Response under 37 CFR 1.116
Expedited Procedure Examining Group
Box: AF
Docket No. 98-035
PATENT APPLICATION

ATTACHMENT FOR CLAIM AMENDMENTS

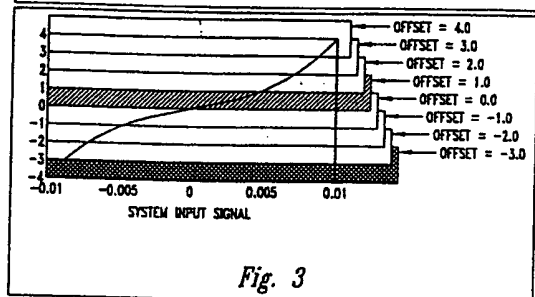
It is not clear how overlapping the offset bands can provide the hysteresis as recited in line 6 of claim 7 since Fig. 3 of the present invention does not show any analog to digital converter and the hysteresis in combination with the offset bands.

By way of further explanation, the hysteresis function is provided for those situations in which the signal being processed is just on the edge of transitioning from one offset range into an adjacent offset range: Suppose hysteresis was not provided. The offset ranges would not overlap as shown in figure 3, but would rather abut one another. In this case, should a signal make a transition from one offset range into the adjacent offset range and then for whatever reason quickly transition back into its original offset range (which could easily be the case for a signal "hovering" close to a range boundary), an undesirable effect of continuously switching ranges could occur. Providing hysteresis in which offset ranges overlap as shown in figure 3 eliminates this effect. Once the signal transitions into an adjacent offset range, it finds itself in the middle of this new range rather than on the range's edge as would be the case if hysteresis were not provided.

Again, the basic idea behind hysteresis is that once an input signal transitions into an adjacent offset range, it finds itself in the middle of this new range rather than on the range's edge as would be the case if the ranges abutted rather than overlapped. Hysteresis prevents a signal from leaving an offset range until it crosses that range's boundary. Once it crosses a range boundary, it then finds itself in the middle of the adjacent range so that it cannot immediately return to the range from which it started. This presents continuous, undesirable range changes.

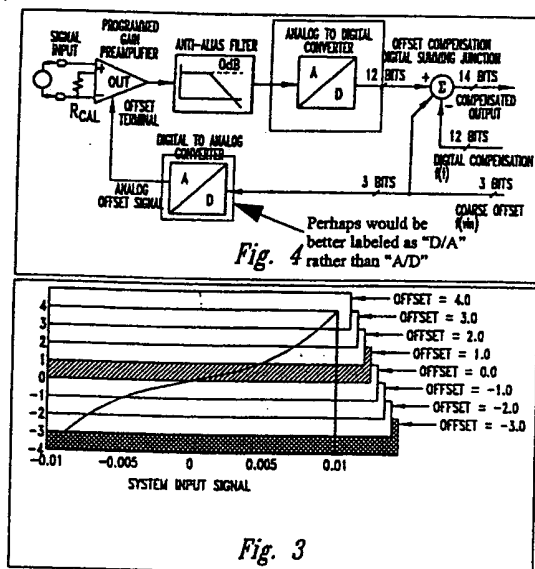
Figure 4 shows two blocks labeled "A/D." Customarily, "A/D" refers to an analog to digital conversion function. One of the blocks shown in figure 4 is in reality a digital to analog converter, customarily referred to as "D/A." This typographical error is possibly confusing to those seeing the figure for the first time.

First, the word "span" in this context refers to the range of voltages which can be accommodated by the analog to digital converter block labeled "A/D" shown in Fig. 4. This "A/D" block must be distinguished from the digital to analog converter block unfortunately also labeled "A/D". The mark-ups on the above figures, hereby made of record, should clarify which is which.

The analog to digital converter is the top block labeled "A/D" in figure 4 and the hysteresis referred to is a mathematical operation shown schematically by figure 3. There is not a dedicated hardware item which performs the hysteresis function. Hysteresis is applied as part of the coarse

offset which originates as part of the device's digital controls. Note that in figure 4 there are three bits controlling coarse offset. These three bits correspond to the eight levels of offset illustrated in figure 3, since $2^3 = 8$ as originally discussed in the patent application's opening remarks.
